### **Meadowbank 2022 Annual Open Pit Geomechanical Inspection**

**RE: Meadowbank Complex - Meadowbank Site - 2022 Annual Open Pit Geomechanical Inspection**

### **Meadowbank Complex - Meadowbank Site - 2022 Annual Open Pit Geomechanical Inspection**

August 12 to 14, 2022

West Wall, Looking North

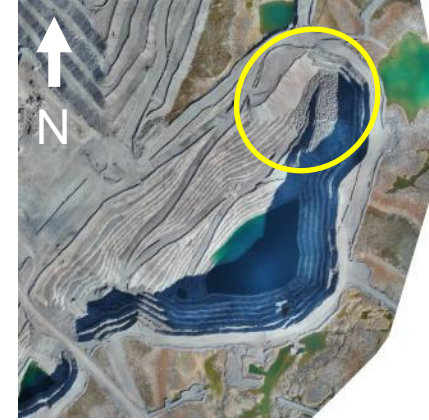
- The West Wall is located along the footwall of the deposit, which dips at approximately 20° to the east (mine grid). The wall was established with 7 m high single benches without pre-shear and commonly failed or were scaled back to the foliation.

- The ramp is located along this wall. At the time of the inspection, access to the ramp was restricted by a barricade. Personnel must contact the Geotechnical Group before entering the open pit; this is understood to be limited to monthly water quality monitoring during the summer.

- While the ramp is inspected as part of the monthly geotechnical inspections, the condition of the ramp is not documented in the inspection report. The ramp should be included in the inspection report. The inspections should continue to consider the open pit walls and in-pit dumps, as well as the integrity of the Ring Road between the open pit and Vault Lake as a failure could result in a wave in the pit lake or inrush to the open pit.

Area 2 Looking South with Subsidence Circled

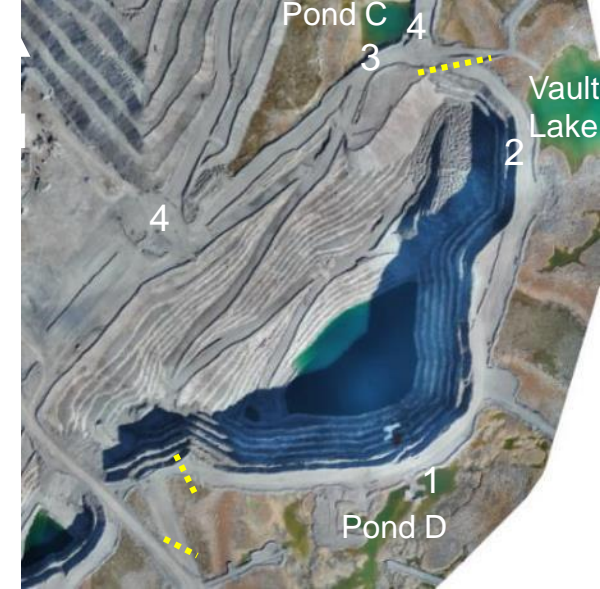
- A berm has been constructed at both ends of the Ring Road to prevent access (yellow dashed lines at right). Several geotechnical hazards have previously been identified along the road:

1. Seepage from Pond D has flowed under the road and down the pit wall in 2019 and 2021. This was not observed during the current inspection; the water level in Pond D is low.
2. Subsidence of the road has occurred adjacent Vault Lake. No change was observed since 2021.

No seepage was observed below road. The potential for a sudden inrush of water from Vault Lake into the open pit was previously identified as a hazard in the event of a breach or erosion of the Ring Road in this area. As a result, it is recommended that the area be inspected prior to accessing the open pit. Alternatively, the road could be purposely breached in this area to eliminate the hazard.

## Vault Open Pit - Ring Road (Cont'd)

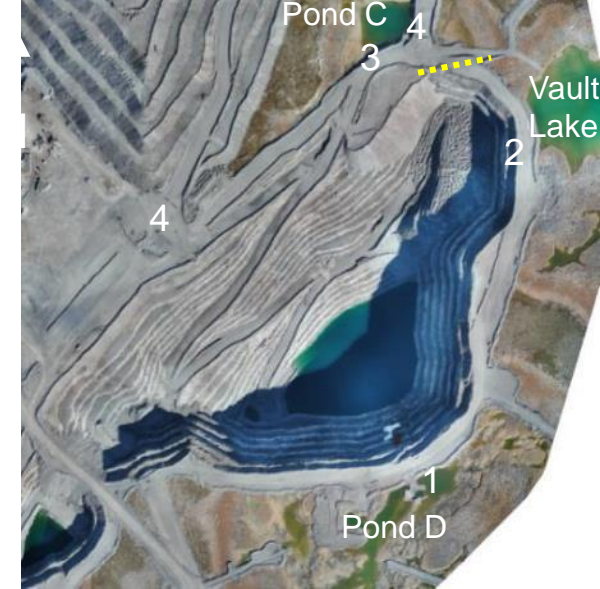
3. Subsidence of the road previously occurred adjacent Pond C. The subsidence has been backfilled and regraded since the 2021 inspection.
4. The ramps to the waste rock dump are only partially blocked by berms. It is understood that the berms were completed in 2022 but have since been removed to allow access to the dump for the crushing operation. The berms should be re-built once access is no longer required.
